## Video Products Technical Bulletin 30-2008-024

DATE: **March 17, 2008**SUBJECT: **REUSE IC101 AND DL401 WHEN REPLACING  
THE A BOARD**MODEL: **PVM-14M4U****DESCRIPTION**

**Figure 1**

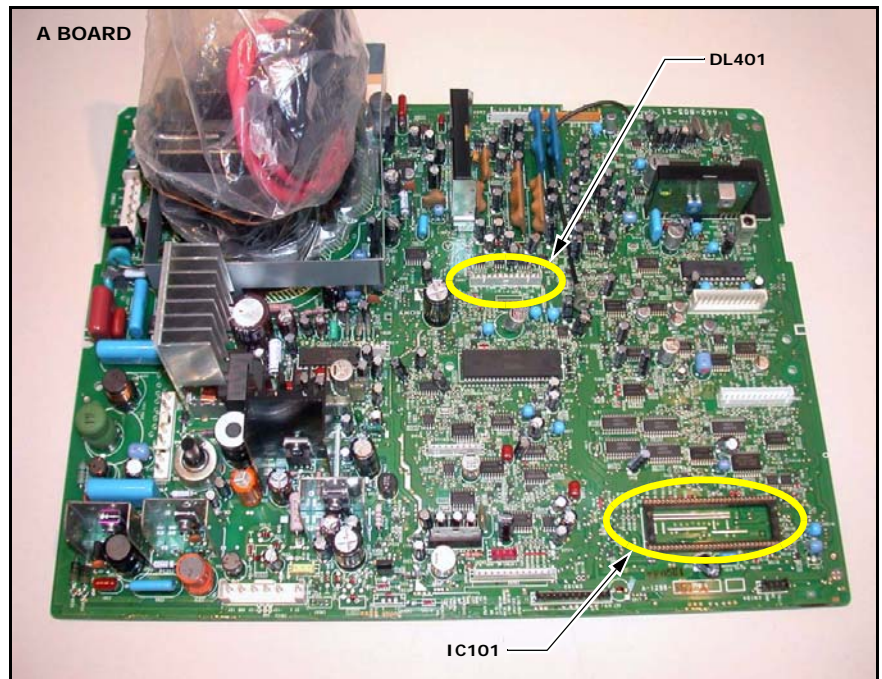
When you replace the A board (A-1298-561-A), remove the following parts from the former board and install them on the new board.

IC101

DL401

The new A board does not contain the parts, and the parts are no longer available. (See Figure 1.)
